From: pak yeung Yung [REDACTED]
Sent: Tuesday, November 4, 2025 3:03 PM
To: tpbpd/PLAND <tpbpd@pland.gov.hk>; TPB Submission/PLAND <tpbsubmission@pland.gov.hk>
Cc: [REDACTED]
Subject: Application No. A/NE-PK/219 - Submission of Further Information

R to C Table

Plan A2(IN)
Scale 1:500

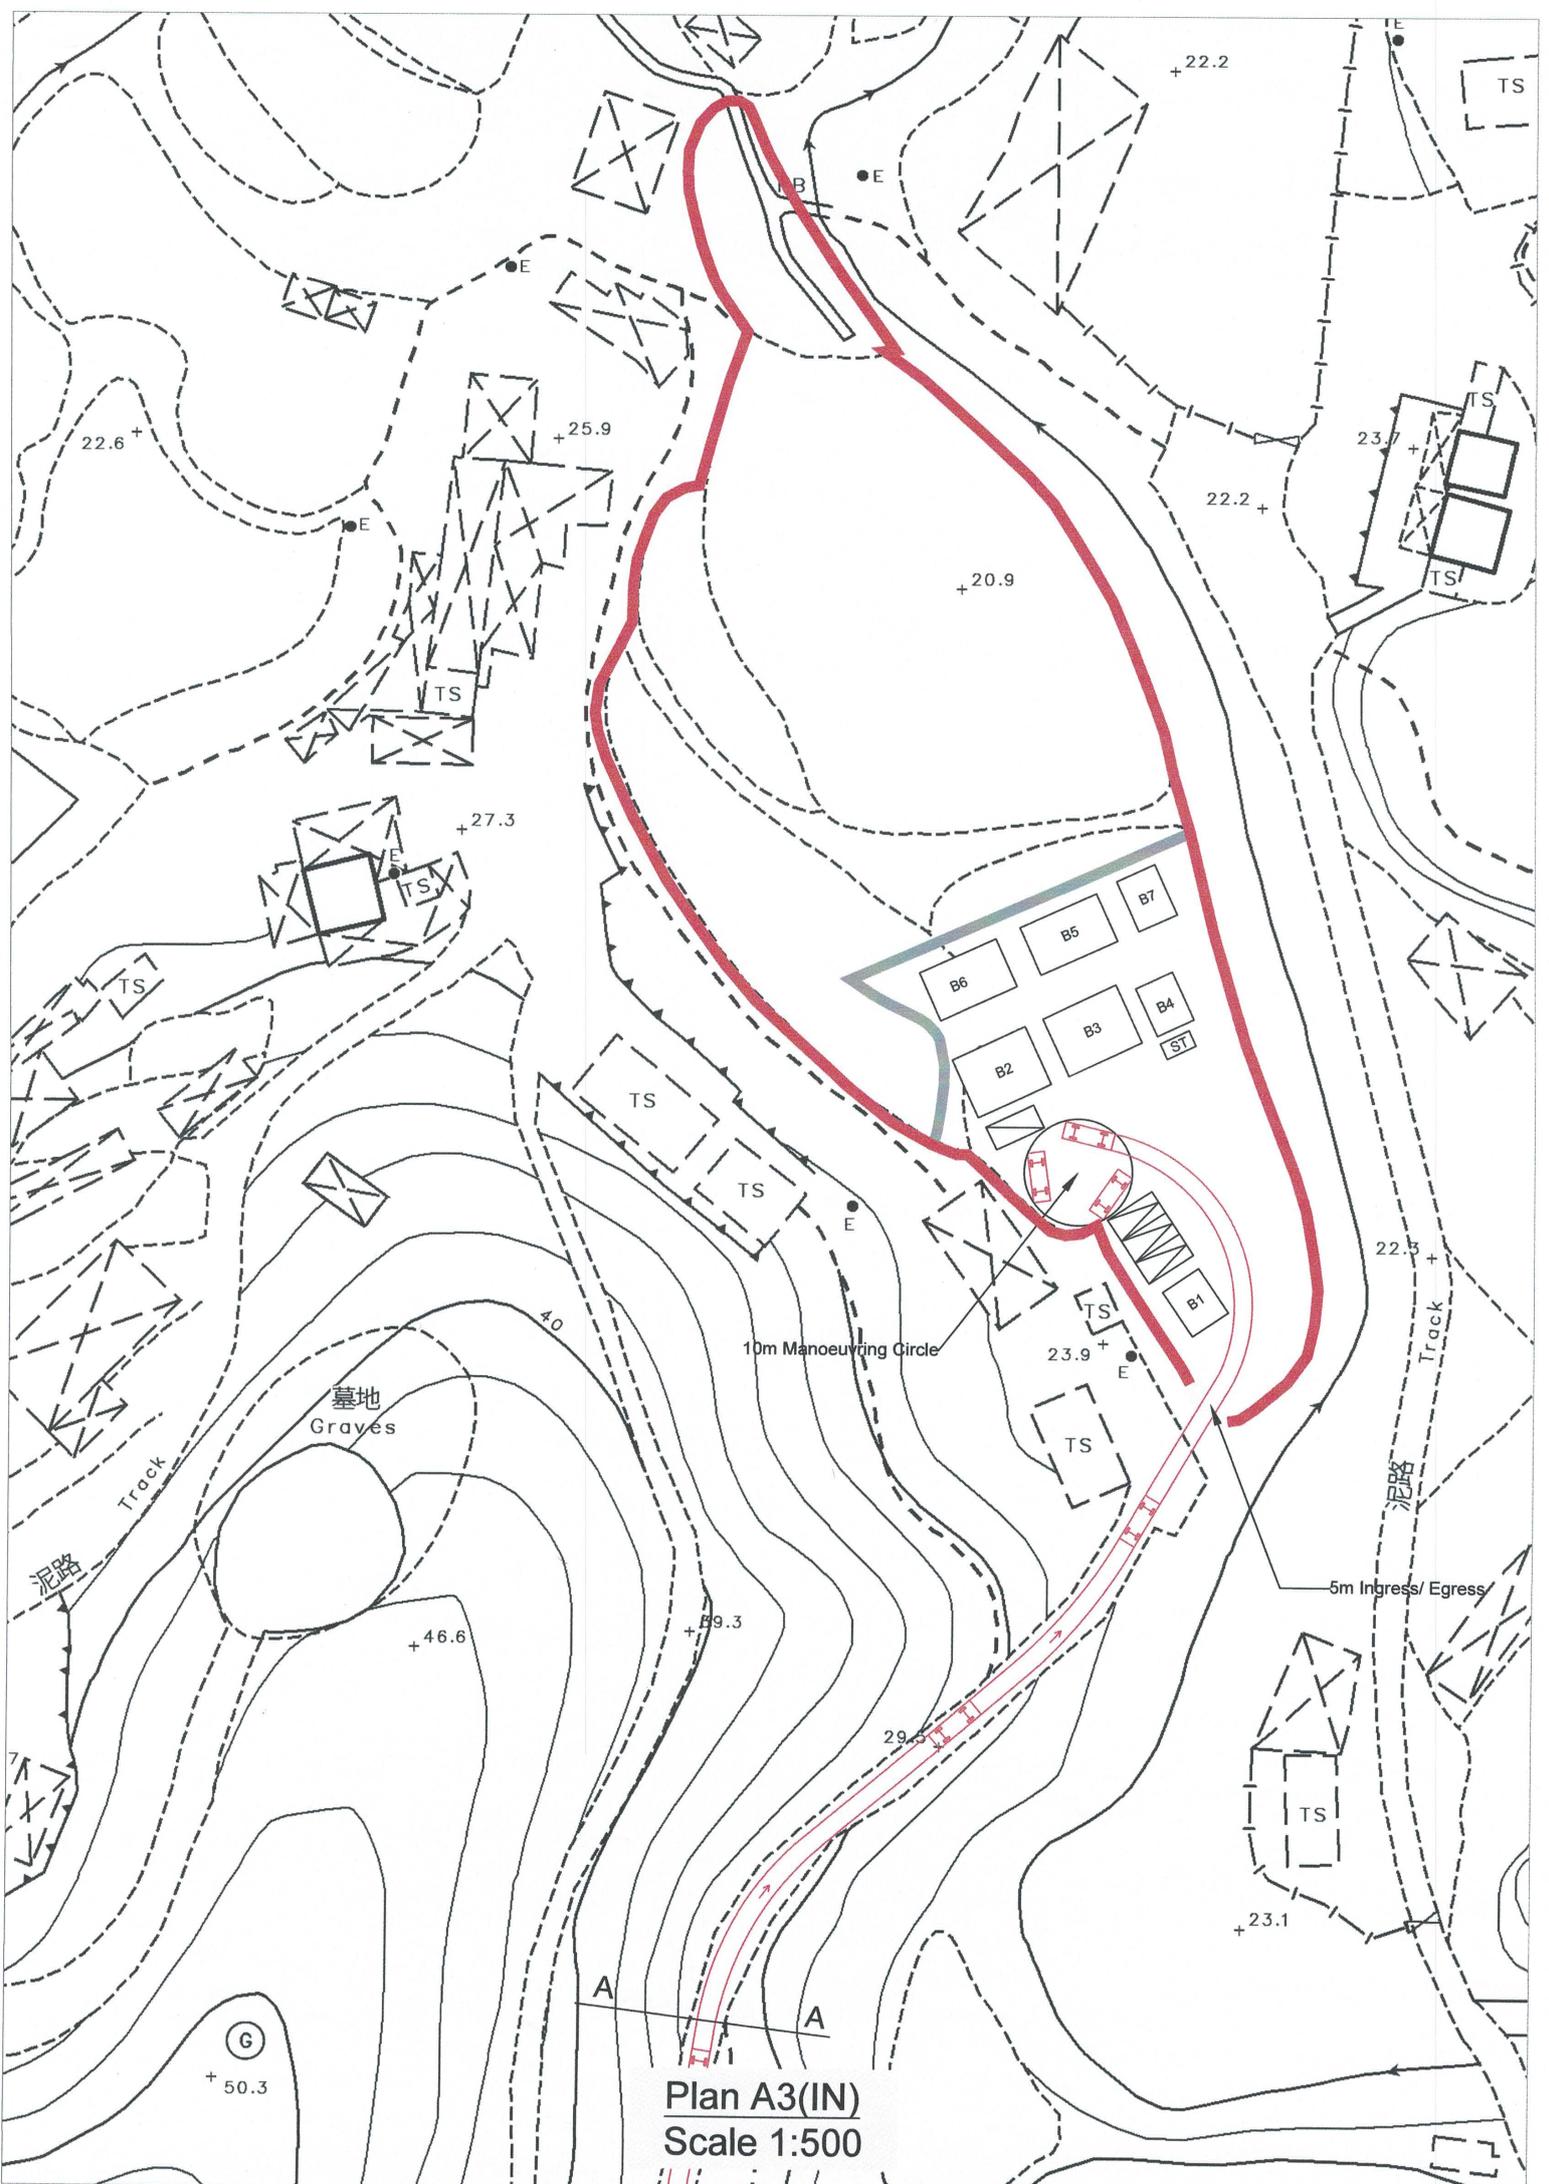
3. Comments of C for T, TD		
(i)	The applicant shall provide a swept path analysis for vehicles manoeuvring into and out of the subject site;	Noted. Please see Plans A1 to A3 and B1 to B3.
(ii)	Noted that advanced booking is required for the visit to the subject site. Please clarify whether there will be a gate installed at the entry. If so, please ensure such arrangement will not cause queuing of vehicles outside the subject site;	Noted. A gate would be installed at the entry. The parking and L/UL facilities would only be opened to visitors with prior appointment. Their time of arrival would be properly regulated so that no simultaneous entry of vehicles would occur.
(iii)	The applicant shall advise the provision and management of pedestrian facilities to ensure pedestrian safety; and	The hard paved area and the field paths/furrows of the farming/ planting areas can serve as pedestrian walkway. Visitors would need to report to the farm office upon arrival and leave. Staff would then guide and manage pedestrian movement to ensure no conflict of pedestrian and vehicular traffic.
